ADDENDUM NO. 1

BEACHCREST WELLFIELD IMPROVEMENTS

LACEY CONTRACT NO. PW 2019-29

SHEET: S-7

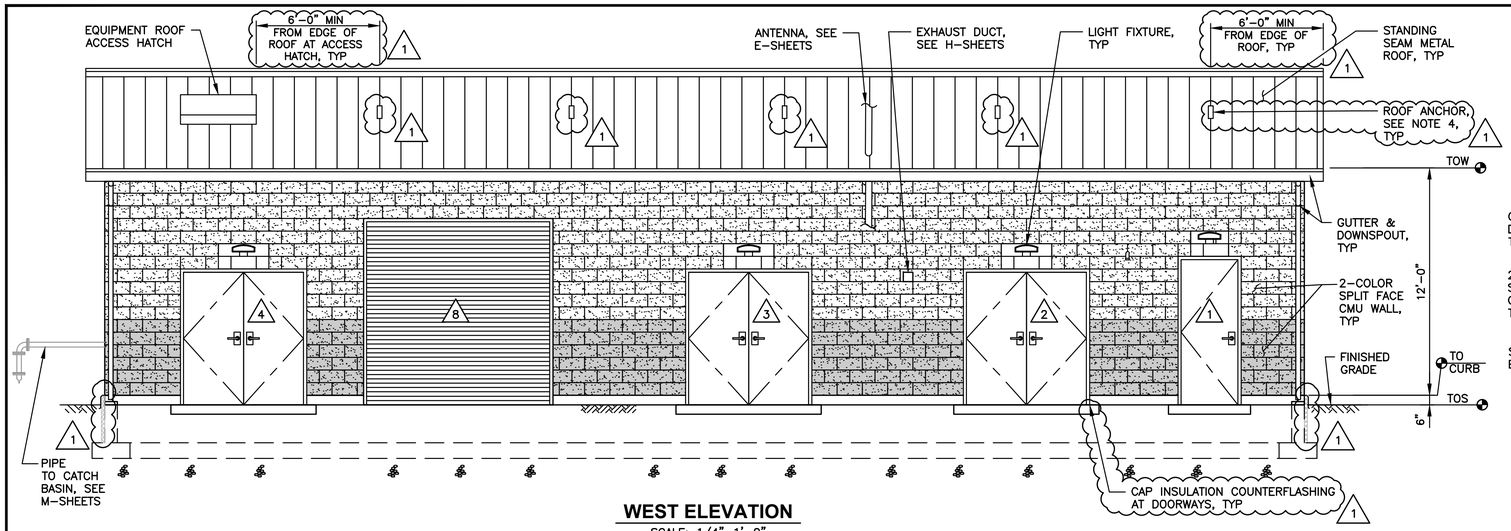
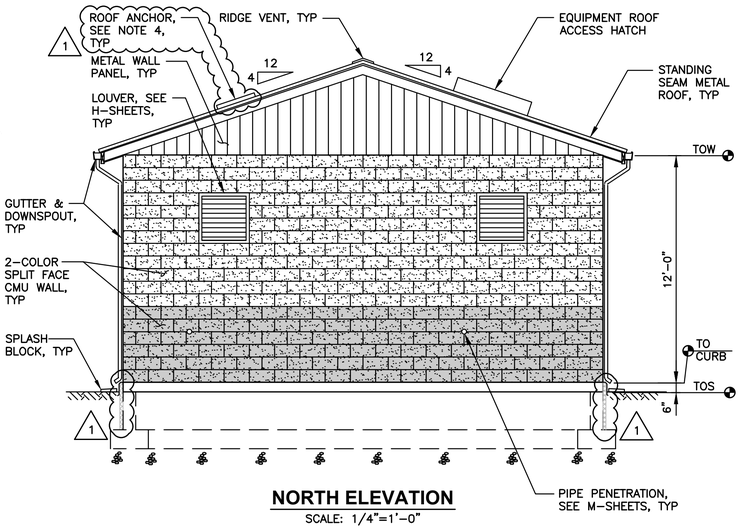
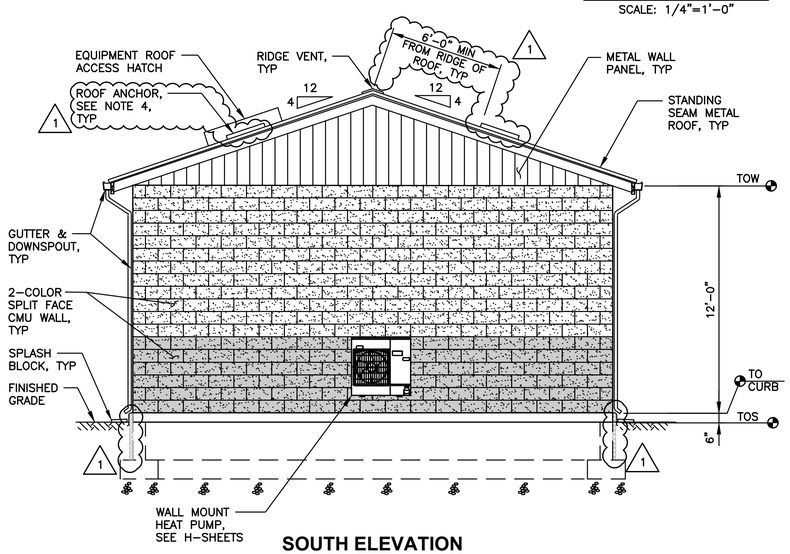
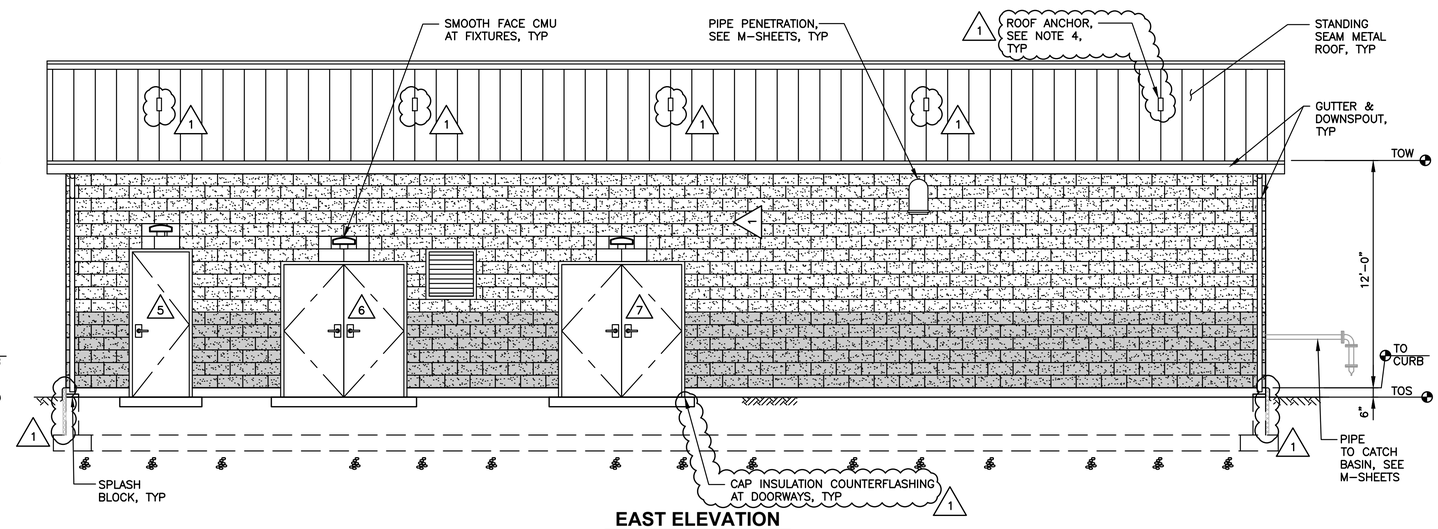
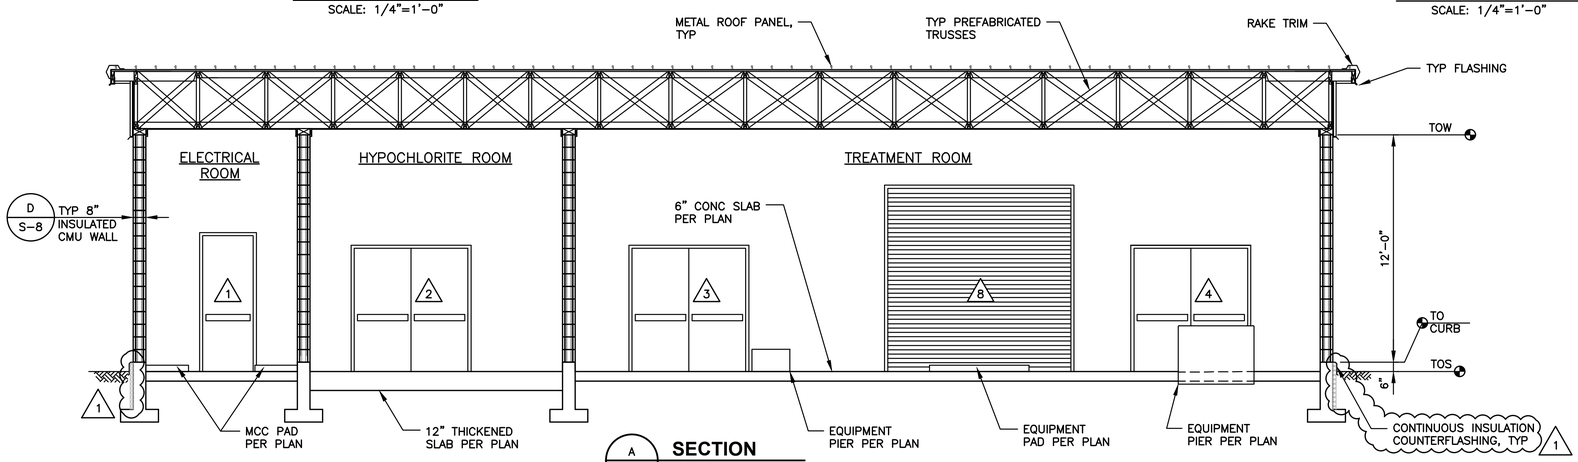
ITEM NO. 1:
Sheet S-7

1) *The revisions include the inclusion of roof anchors on Sheet S-7.*

Delete Sheet S-7 and replace it with the new page as attached.

1. PIPING NOT SHOWN FOR CLARITY, SEE M-SHEETS.
2. SUPPORTS AND BRACES FOR MECHANICAL PIPES MAY NOT BE ATTACHED TO ROOF STRUCTURE. THEY SHALL BE ATTACHED TO CMU WALL OR CONCRETE FLOOR.
3. NOT ALL PENETRATIONS MAY BE SHOWN. CONTRACTOR SHALL VERIFY NUMBER, SIZE AND LOCATIONS OF ALL OPENINGS WITH MECHANICAL, ELECTRICAL, AND HVAC DRAWINGS.
4. ROOF ANCHOR SHALL BE FALL PROTECTION DISTRIBUTORS SSRA1 STANDING SEAM ROOF ANCHOR, OR EQUAL. LOCATE AND INSTALL PER MANUFACTURER'S RECOMMENDATIONS. PROVIDE 10 ROOF ANCHORS TOTAL.

D / S-5 **SECTION**
SCALE: 3/4"=1'-0"

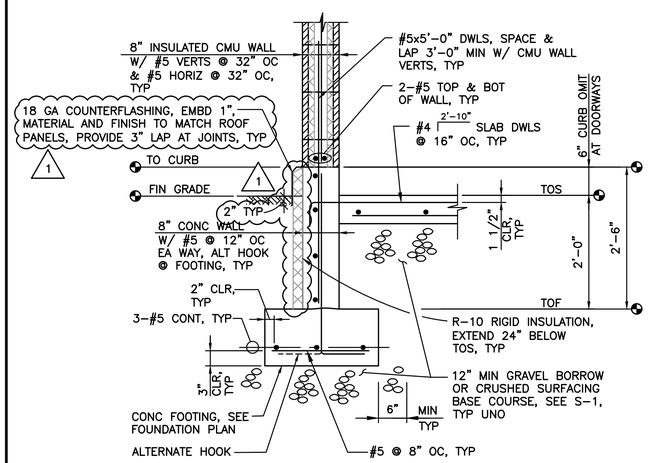
ITEM NO. 2:
Sheet S-8

2) *The revisions include modifications to Section D on Sheet S-8.*

Delete Sheet S-8 and replace it with the new page as attached.
